# CITY OF LONG BEACH

October 9, 2017

Approve a Certificate of Appropriateness request for a 980-square-foot two-story addition to an existing 1,220-square-foot two-story rear unit with an attached two-car garage and construction of a new 441-square-foot detached two-car garage for the existing front unit located at 627 Temple Avenue. The existing building is a Contributing Structure within the Rose Park South Historic District. (District 2)

APPLICANT: Hung N. Le  
12571 Camus Lane, #5  
Garden Grove, CA 92841  
(Application No. HP17-330)

UNIT 2 - EAST ELEVATION (FRONT VIEW)  
SCALE 1/4" = 1'-0"

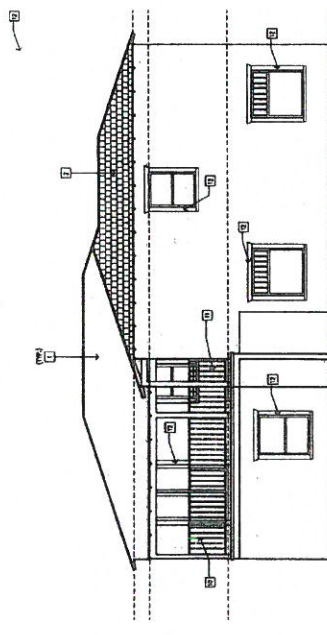
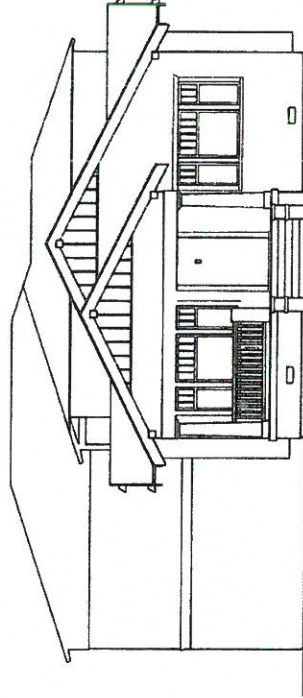
The overall height of the existing front unit is 19-feet measured from grade to the top of pitch with a 6"/12" roof slope. The existing two-story rear unit has an overall height of 21-feet 6-inches with a roof pitch of 4"/12" pitch. The proposed two-story addition will have an overall height of 20-feet 6-inches with a roof pitch to match the existing 4"/12". The new one-story, detached two-car garage will have an overall height of 14-feet (11-feet from the mid-point of the roof) and will match the roof pitch of the front unit (6"/12" pitch). The height of the addition will be lower than the previous height established on the existing rear unit and will visually blend with the existing structures, maintain the building scale at a reasonable size so that it will not overpower the structure, and remain in character with the neighborhood scale. The neighborhood along Temple

The primary window style throughout the existing residence is wood sash single-hung windows. In the new two-story addition, all new proposed windows will be wood sash single-hung. The proposed detached two-car garage will not have any windows incorporated with its design. The proposed two-car garage will have an aluminum roll-up garage door painted to match the body of the garage. Staff has included a Condition of Approval to allow the applicant to continue to work with staff on the final selection of the garage door.

In order to make the proposed two-story addition consistent with the existing structures, several architectural features and materials are incorporated including the same roof slope established on the existing rear unit, same composition shingle, exposed rafters, the same size of horizontal siding, and decorative wood sash single-hung windows and trim. The materials for the proposed one-story, detached two-car garage will have matching materials associated with the rear unit.

While the new improvements are compatible with the existing residence's Craftsman Bungalow architectural style, it's equally important that the new improvements are visually distinguished from the historic building. The improvements should not give a false sense of the property's historical development. The Secretary of Interior's Standards for Rehabilitation, Standard No. 9 states that "new work shall be differentiated from the old and shall be compatible with the massing, size, scale and architectural features..." To achieve that standard, both the two-story addition and the new detached two-car garage will be utilizing a different siding pattern of equal horizontal wood planks compared to the original two different sized horizontal wood planks.

NEW GARAGE EAST - WEST ELEVATION (FRONT/REAR VIEW)  
SCALE 1/4" = 1'-0"

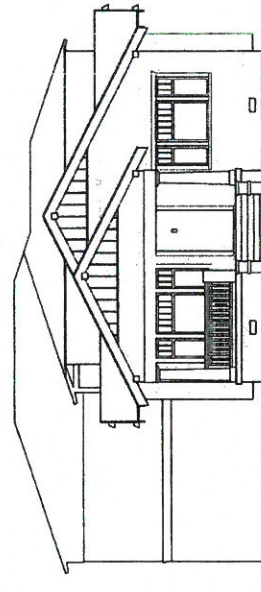
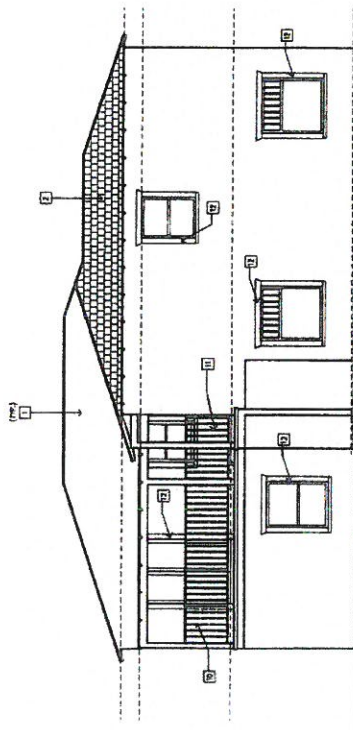
10. The style and type of garage door proposed shall be subject to further review and approval from Planning Bureau staff.
11. All proposed landscaping shall be subject to Chapter 21.42 of the Zoning Code.

**A motion was made by Commissioner van Dijs, seconded by Commissioner Smith, to approve recommendation with the added conditions to work with the applicant to reduce the massing and blocking of the new garage, work on the final details of the perimeter fence along the alley, and incorporation of a grasscrete finish or other permeable subsurface along the approach of the new garage.**
